REMARKS

Amendments to the Drawings:

FIG. 1

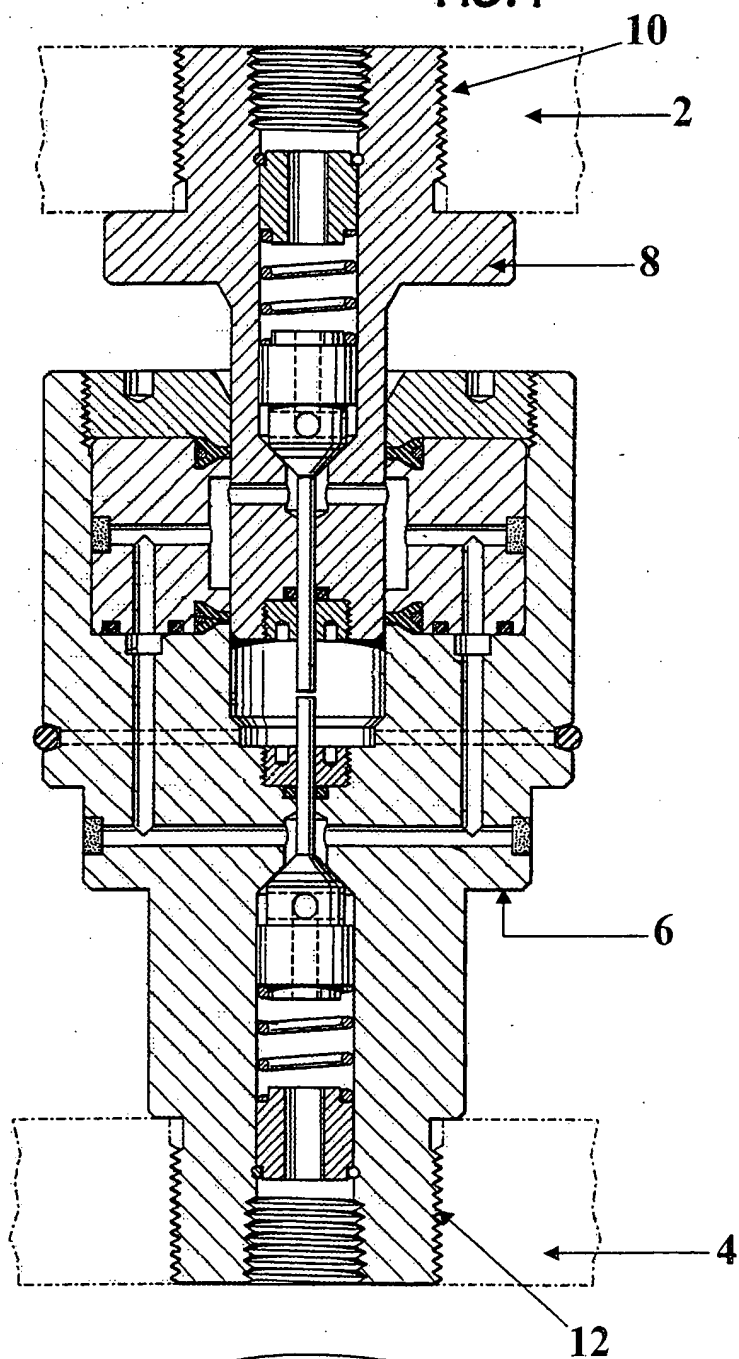
Figure 1 has been amended per the requirement of the Office Action to designate the hydraulic coupling illustrated therein as “Prior Art.”

The attached sheet of drawings includes changes to Fig. 1. This sheet, which includes Fig. 1, replaces the original sheet including Fig. 1. In Figure 1, the annotation "Prior Art" has been added.

Prior Art

added
